Project	IEEE 802.16 Broadband Wireless Access Working Group < http://ieee802.org/16 >	
Title	amendment for MBS primitive	
Date Submitted	2006-11-15	
Source(s)	ZTE corporation	xu.ling@zte.com.cn jqian@zte.usa.com chuang@zte.usa.com

Re:	Contribution on comments to P802.16g-D5	
Abstract	In this contribution, we propose to add MBS Info attribution within MBS primitive and some clarification about MBS related attribute.	
Purpose	Adoption	
Notice	This document has been prepared to assist IEEE 802.16. It is offered as a basis for discussion and is not binding on the contributing individual(s) or organization(s). The material in this document is subject to change in form and content after further study. The contributor(s) reserve(s) the right to add, amend or withdraw material contained herein.	
Release	The contributor grants a free, irrevocable license to the IEEE to incorporate text contained in this contribution, and any modifications thereof, in the creation of an IEEE Standards publication; to copyright in the IEEE's name any IEEE Standards publication even though it may include portions of this contribution; and at the IEEE's sole discretion to permit others to reproduce in whole or

Figure 517— MBS Configuration management Primitives (Create and Delete)

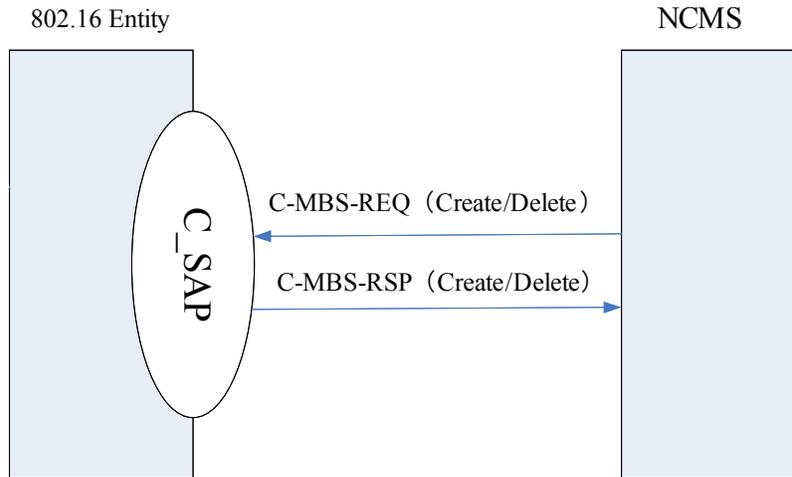
In the current baseline document, it has a MBS section. In this section, there has defined how to set MBS information to a BS, but if the information has been changed, it does not specify clearly how BS will do. To resolve the issue, this contribution adds some clarifications about this issue. It also adds new MBS primitives to give the information of MBS attribute which will initiate the air link to be created or deleted.

14.2.12.3 MBS Configuration management

This primitive can be from IEEE802.16 entities or NCMS, and is used to notify the BSs which are in one MBS zone to create a new MBS transmitted radio link

When Operation Type is set to 'Delete', this primitive shall be used to initiate an existing MBS radio link deletion by NCMS.
